3.0 Kingsway UKPN Substation Upgrade

4.0 Fabric to be retained which was originally approved to be demolished under planning permission and listed building consent (refs: 2019/2773/P and 2019/2790/L).

5.0 Demolition Areas

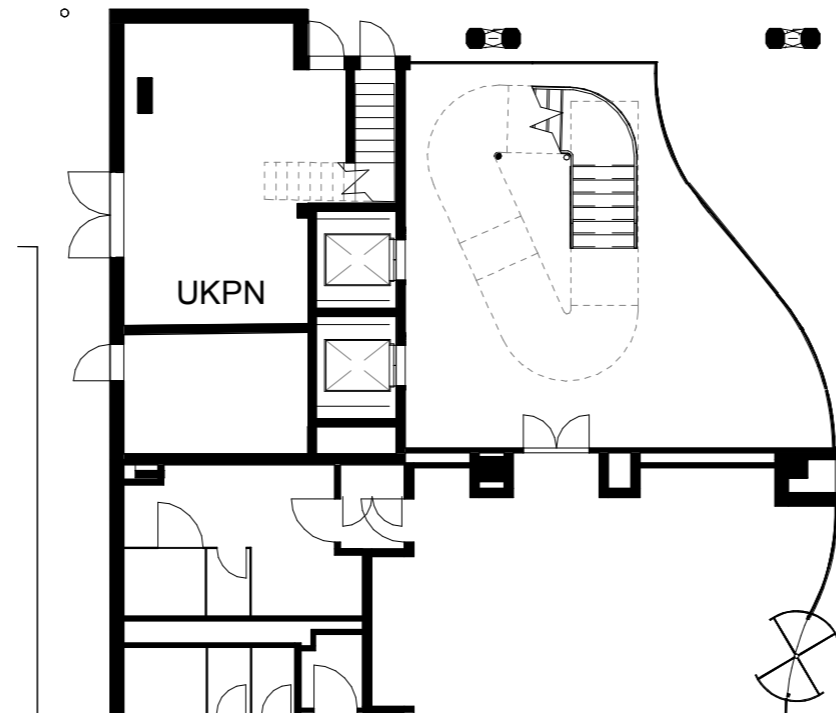
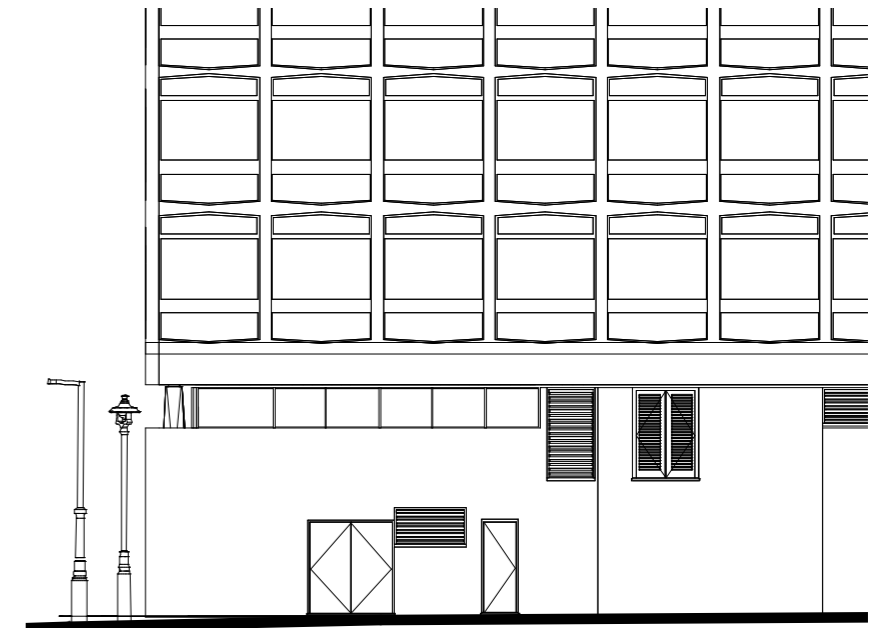
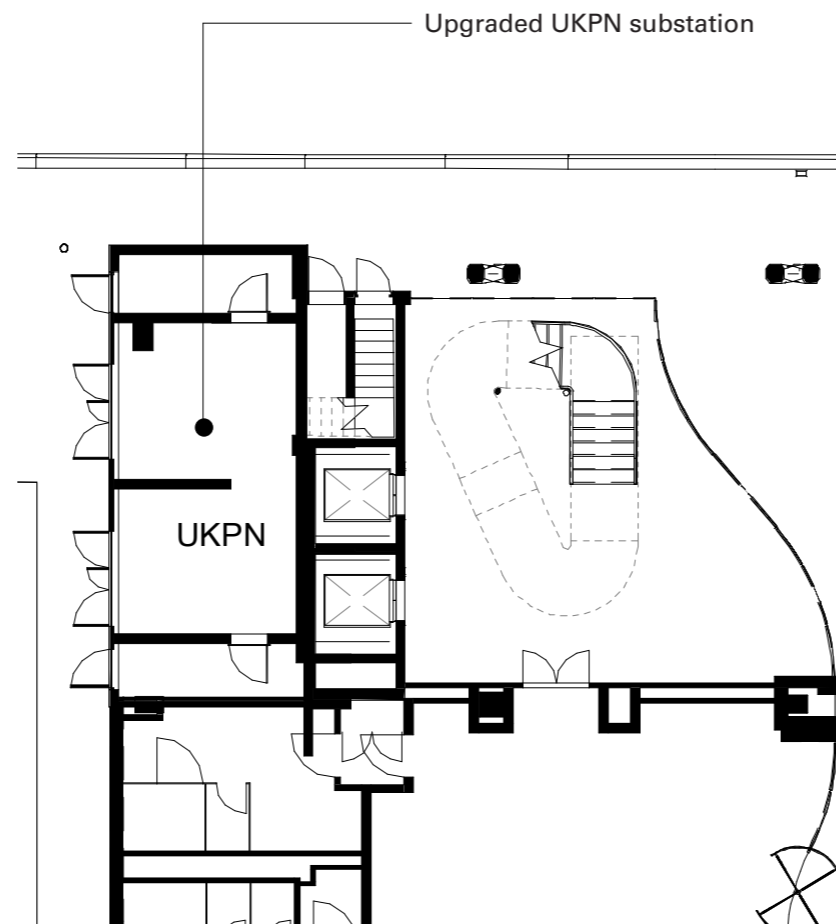
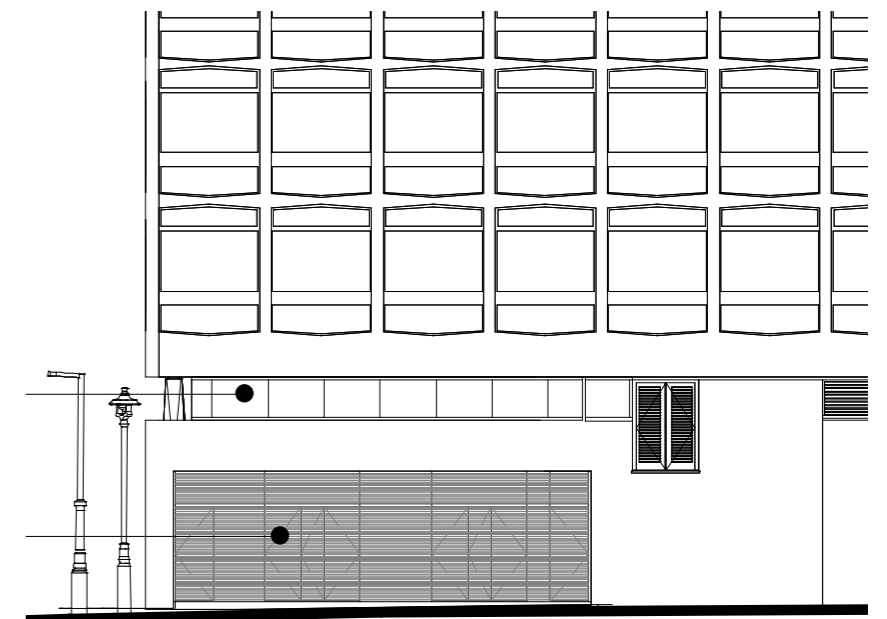
UKPN's ventilation requirements for the upgraded substation are larger than the existing condition, and require areas of ground floor and mezzanine slabs to be demolished, along with the removal of brickwork and existing louvres to the west facade.

Following the June pre-application meeting, we received comments from Camden in the letter ref: 2020/2733/PRE regarding the proposed amendments to the substation: "Kingsway west elevation louvre and brickwork changes - the openings appear more coherently arranged. The impact on significance is anticipated to be neutral."

The proposals have been reviewed with UKPN, however the final construction details and samples of louvres are not yet available and require further input from UKPN. The final construction details and samples for the proposed UKPN substation upgrades will be submitted to Camden via Condition 3LBC I) of the Listed Building consent ref: 2019/2790/L.

Basement 01 - fabric to be retained that was originally approved to be demolished

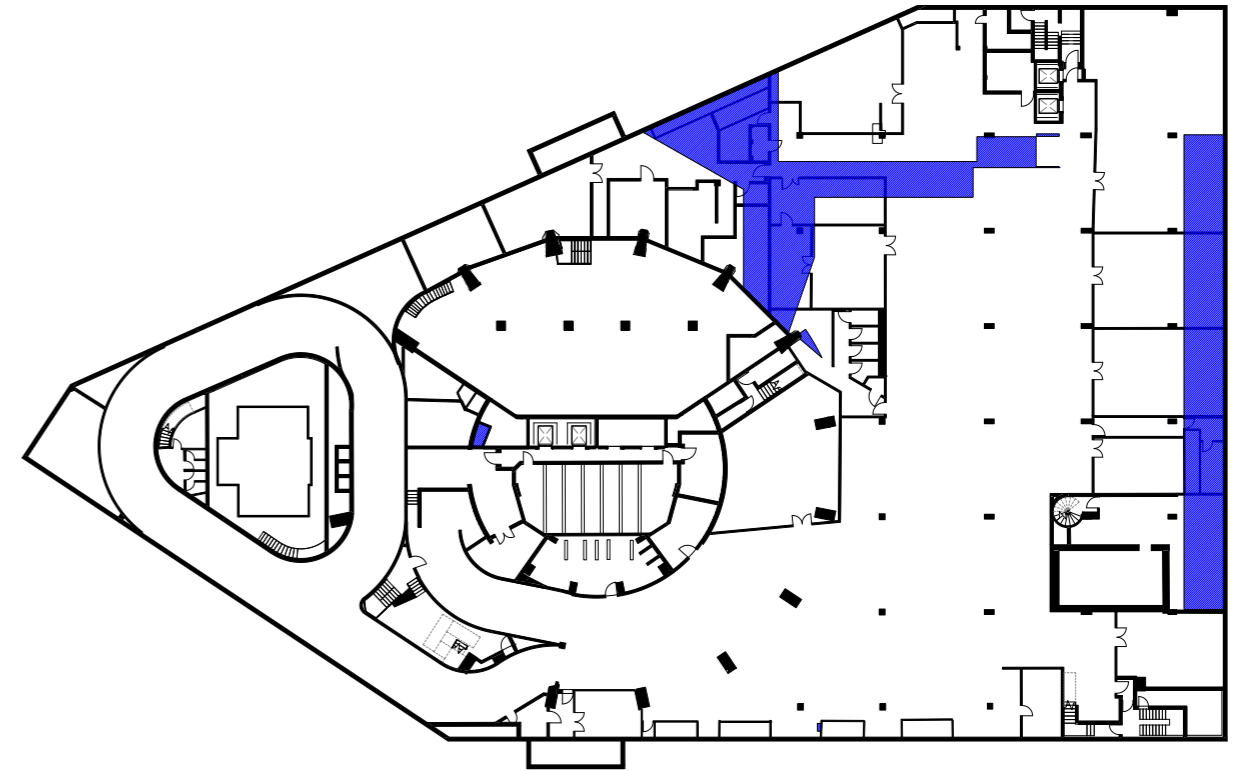
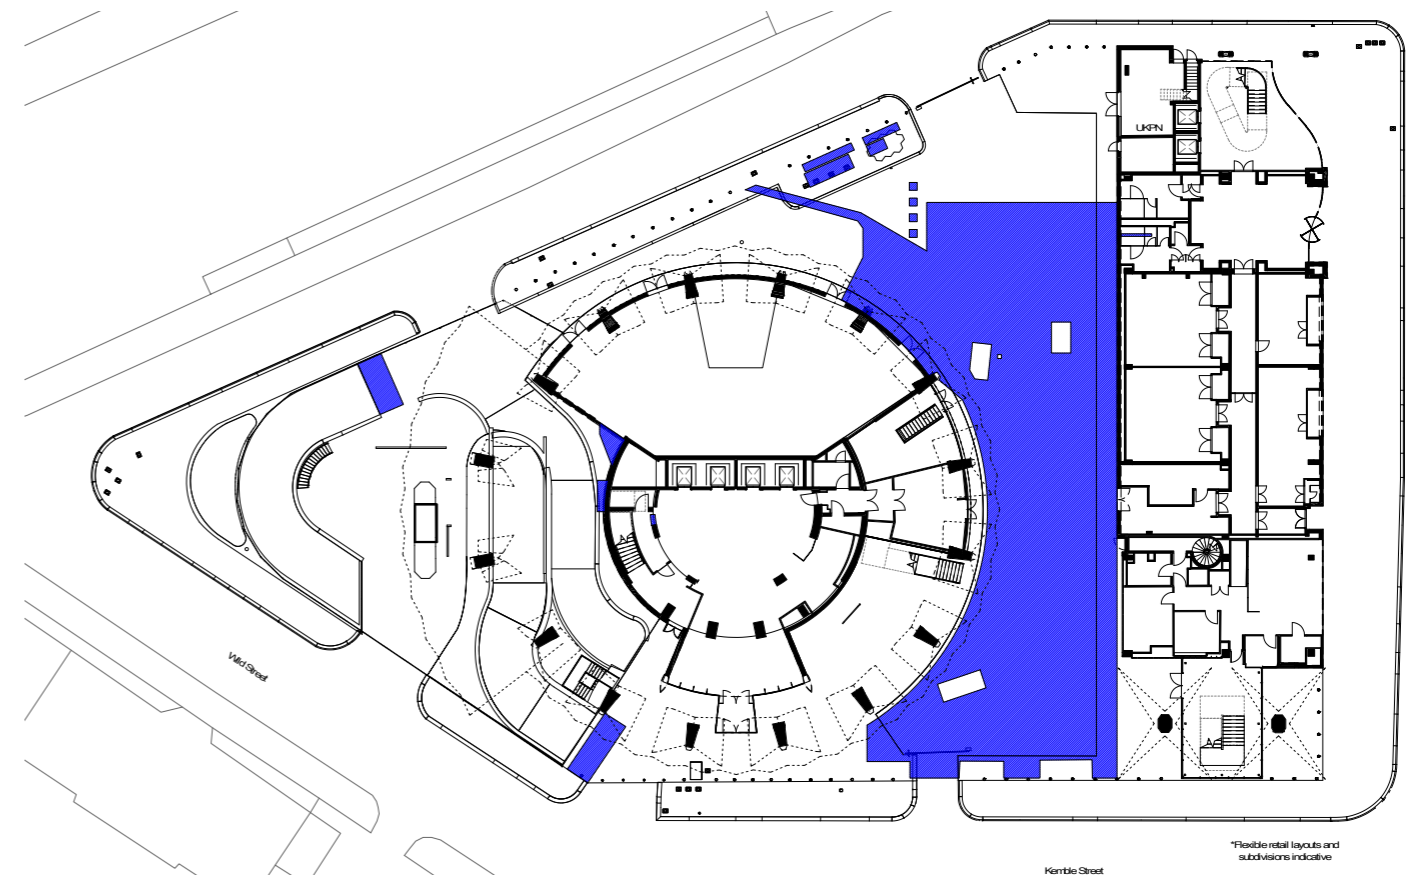
The approved scheme consented the demolition of listed fabric to create a long void along the eastern boundary wall which is used for smoke clearance of the basement 02 level.

As discussed during the pre-application addendum in September 2020, we are proposing to retain this fabric and not create the void because the MEP design now allows for smoke extract ductwork within the Sui Generis space.

Furthermore, there is another large area of basement 01 slab to the north of the site that has approval for demolition. This is also not required following detailed design development and the proposal is to retain the fabric in this area.

Ground Floor - fabric to be retained that was originally approved to be demolished

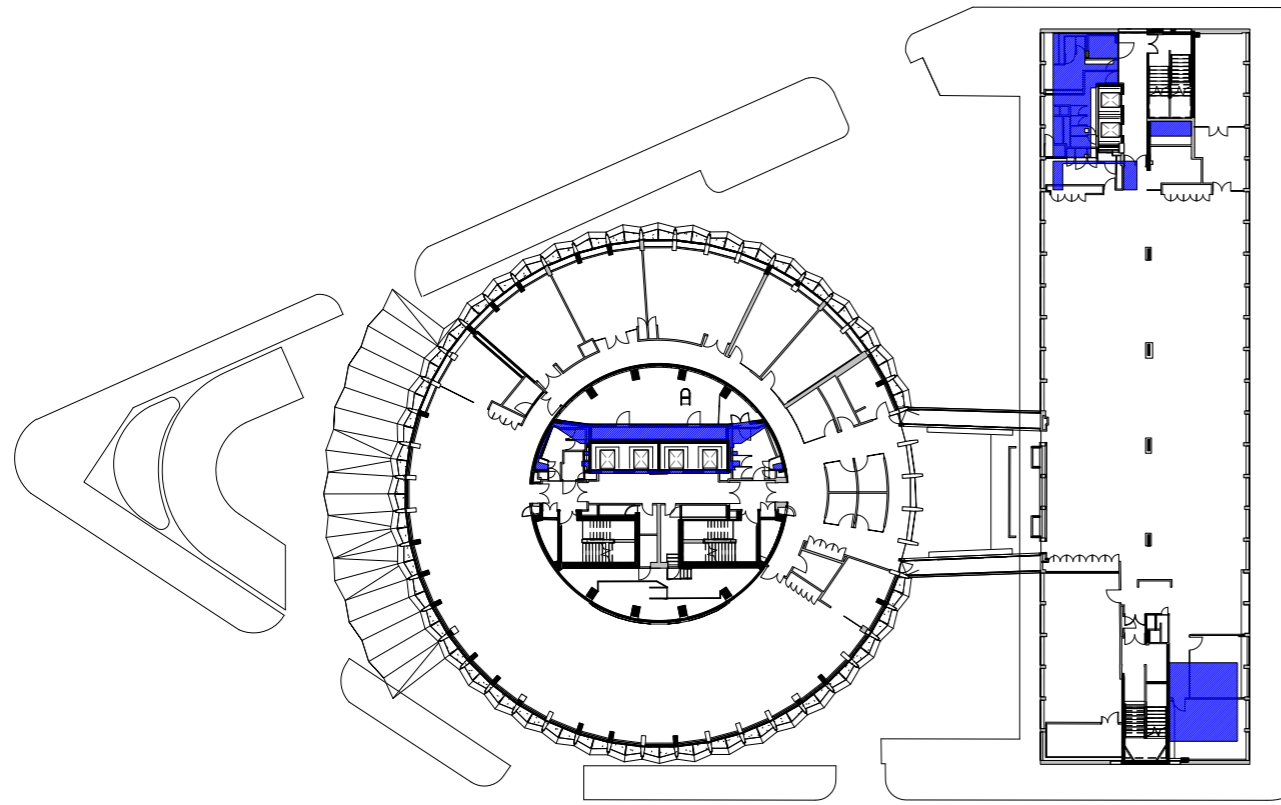
The proposal is to retain as much of the existing ground floor slab as possible between the Tower and Kingsway buildings. The penetrations that remain will be for ventilation ductwork connections. The final location, size and quantity of penetrations in the Ground Floor slab could alter to suit site discoveries once the basement strip out has been completed. Furthermore, the Main Contractor may require minor alterations to suit the final detailed design.
